Appendix G

Errata from 1994 Hanford Site Environmental Report

The following lists errors in the published 1994 environmental report (*Hanford Site Environmental Report for Calendar Year 1994*. R. L. Dirkes and R. W. Hanf,

Figure 5.6.7. Concentrations (± 2 standard error of the mean) of Uranium-238 in Milfoil Collected from Five Locations on the Columbia River. As a result of figure scale, some uncertainties are concealed by the point symbol.

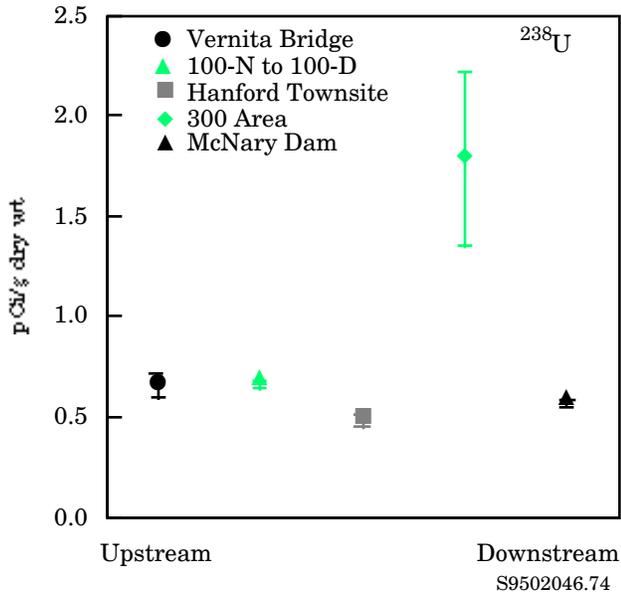
On page 175, second column, bottom paragraph, third line, there is a callout for Figure 5.6.7. This figure was omitted from the report.
